**ADDRESS: 614 PINE ST**

Proposal: Construct rear addition and roof deck

Review Requested: Final Approval Owner: Qian Jin Real Estate LLC Applicant: Sam Xu, Constrecture, LLC

Figure 2: Rear ell of subject property as seen from Waverly St (beyond the ivy-covered wall). Image from Cyclomedia.phila.gov.

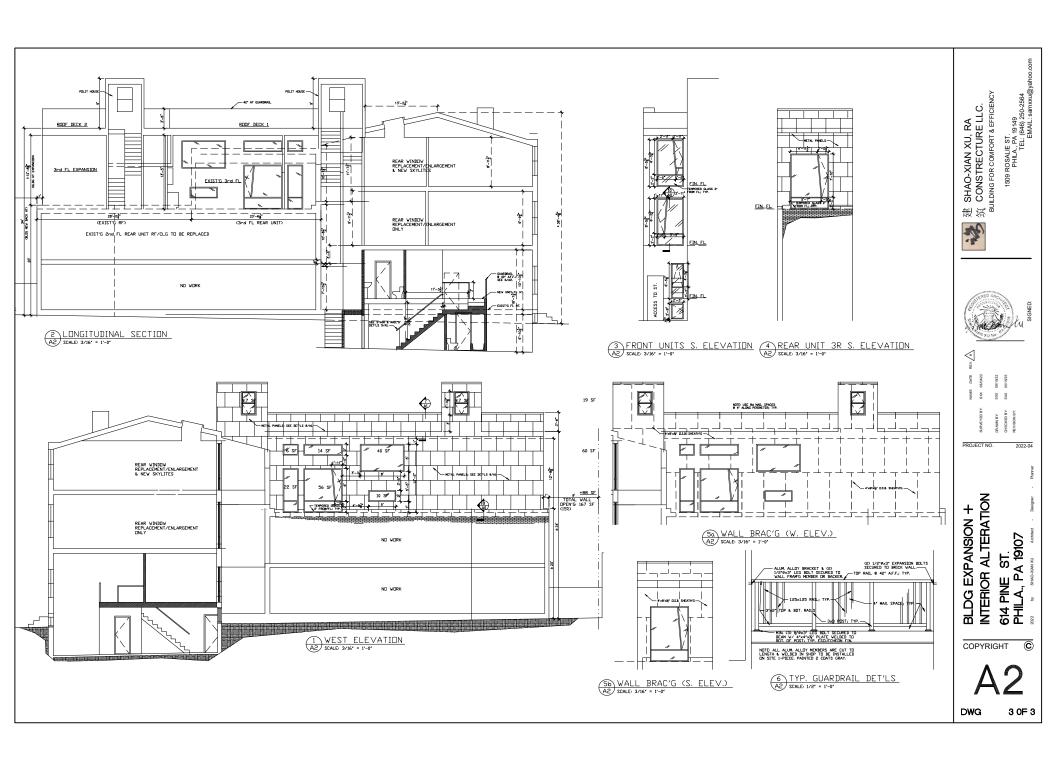
- The third-story addition is very tall with a very large floor-to-ceiling height. The addition should be reduced in height by several feet.
  - No details are given for the cladding on the east elevation. Given the visibility from Waverly Street, it should be clad in a way that is compatible with the existing brick walls.

**STAFF RECOMMENDATION:** Approval, provided the parapet wall is replaced with a black metal picket railing and the cladding is revised to be more compatible with the existing building, with the staff to review details, pursuant to Standard 9 and the Roofs Guideline.
